MC GUIRE NUCLEAR STATION, UNIT 1

AMENDMENT TO FACILITY OPERATING LICENSE

Amendment No. 128
License No. NPF-9

McGUIRE NUCLEAR STATION, UNIT 2

Figure 2.1-1a Reactor Core Safety Limits -
Four Loops in Operation (Unit 1)

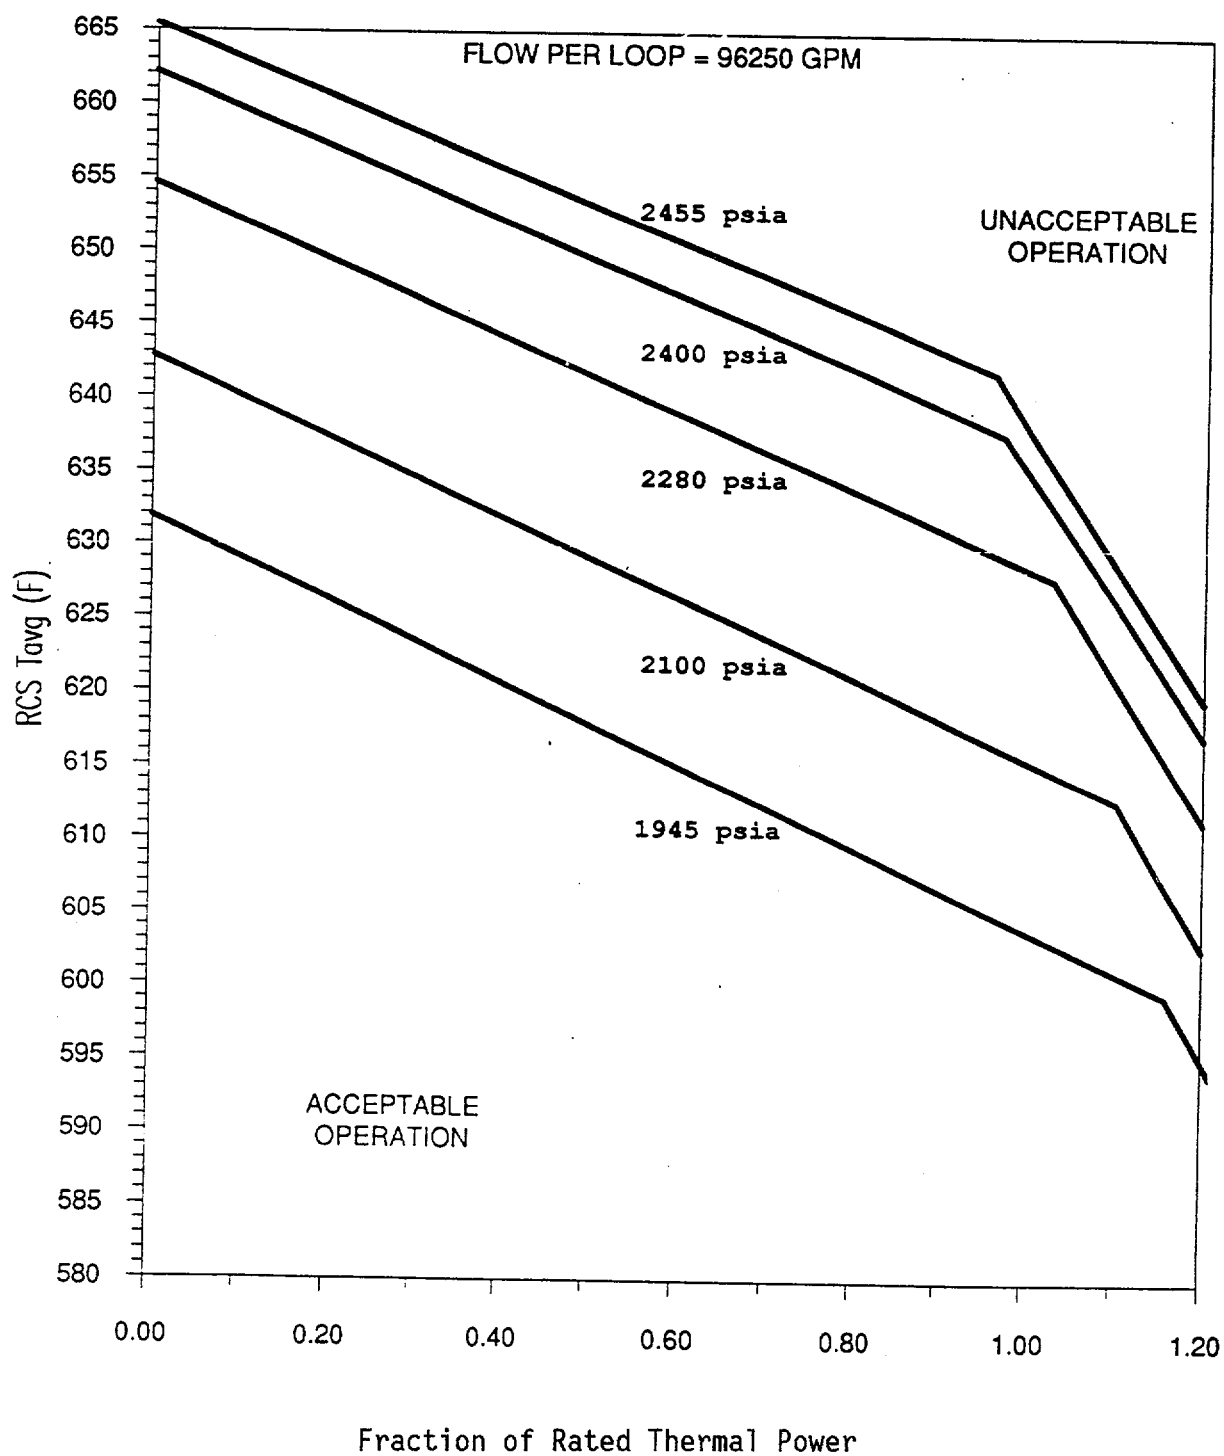
(1) Core Safety Limits (Figure 2.1-1)

Figure 2.1-1 of the TS is revised to reflect the use of BWCMV CHF correlation and DPC's statistical core design methodology with a 1.55 design DNBR limit. The revised core safety limits are based on a full core of Mark-BW assemblies. The licensee addresses the transition core penalty for OFA fuel by applying a 3.8% DNBR penalty against the 10.7% generic margin included in the design DNBR limit. Since the BWCMV CHF correlation and the SCD methodology are approved we conclude that the revised core safety limits are acceptable for Unit 1; these changes are not applicable at this time to Unit 2.

Figure 3.2 - 1. Reactor Coolant System Total Flow Rate Versus Rated Thermal Power - Four Loops in Operation

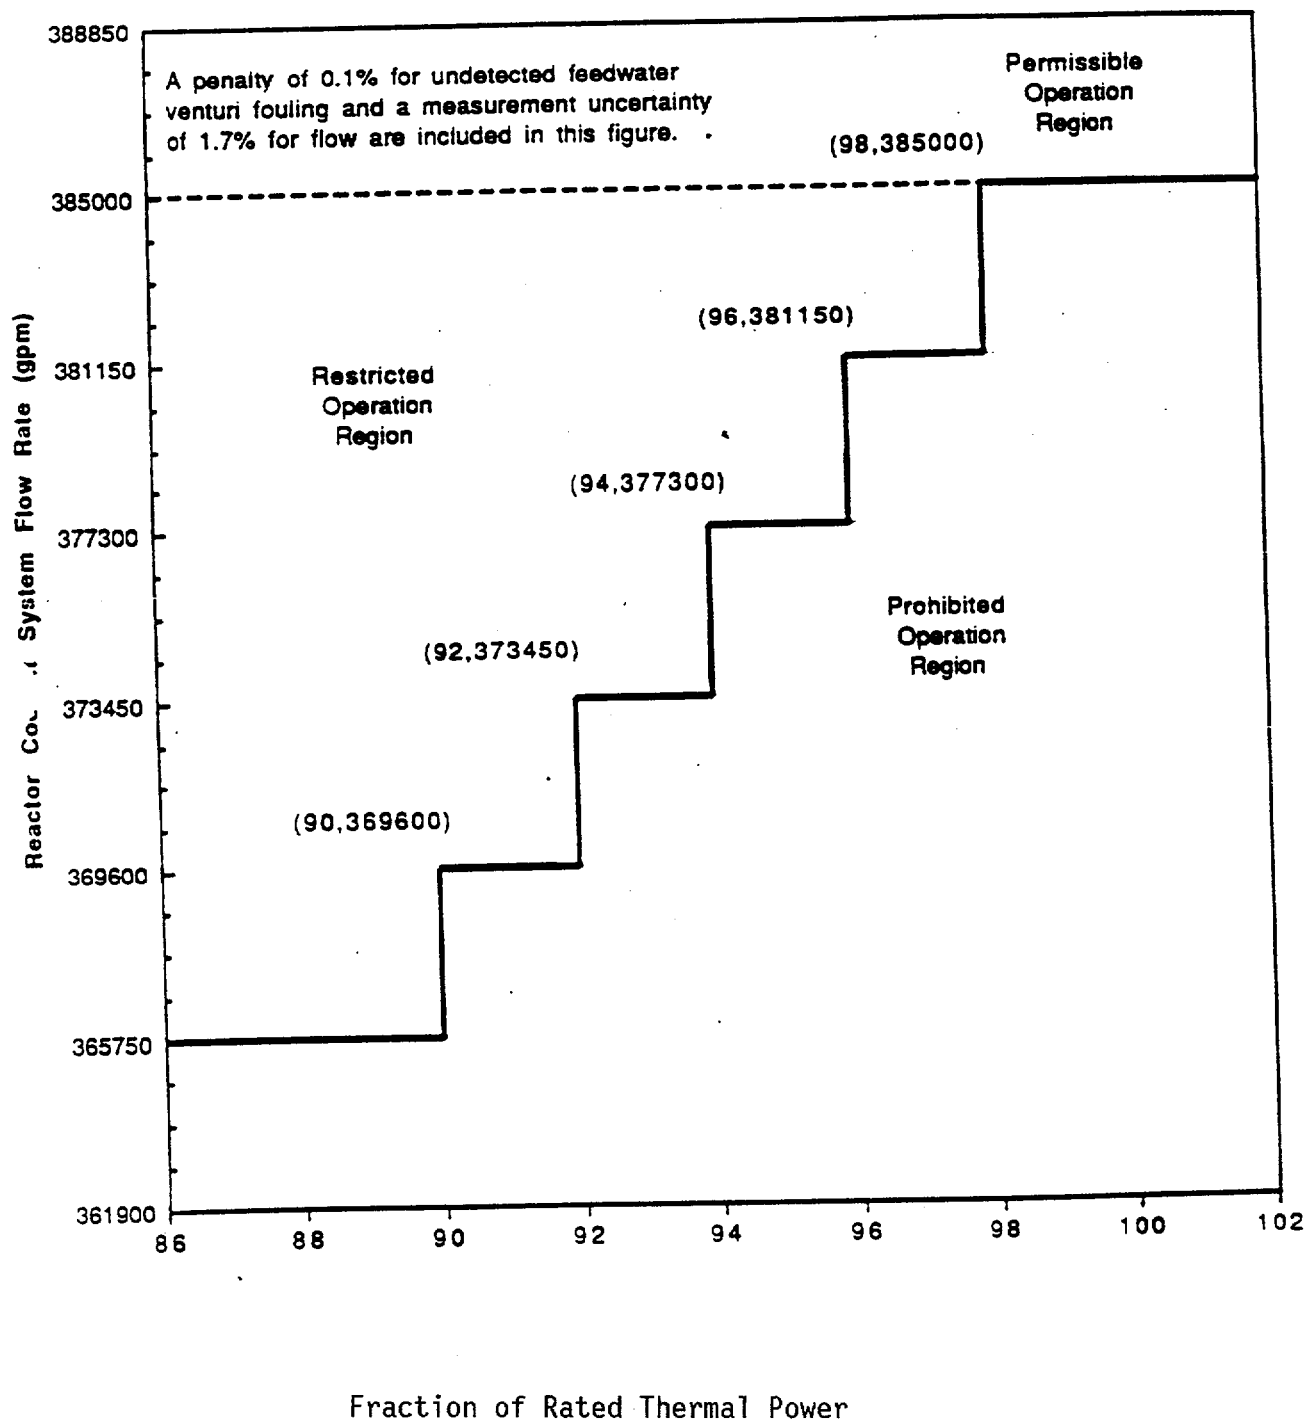
TS 3/4.2.5 DNB Parameters - The reactor coolant flow rate limit is moved from TS 3.2.3 to this TS, and is incorporated in a new Figure 3.2-1, where it is combined with the power level to provide permitted, restricted or prohibited operating regions. This figure defines trade-offs in power and flow and has been verified by a number of thermal evaluations. It provides comparable margins to those provided in the previous Westinghouse design TS 3.2.3, which is now revised. The change is in accord with the approved methodology and is acceptable.
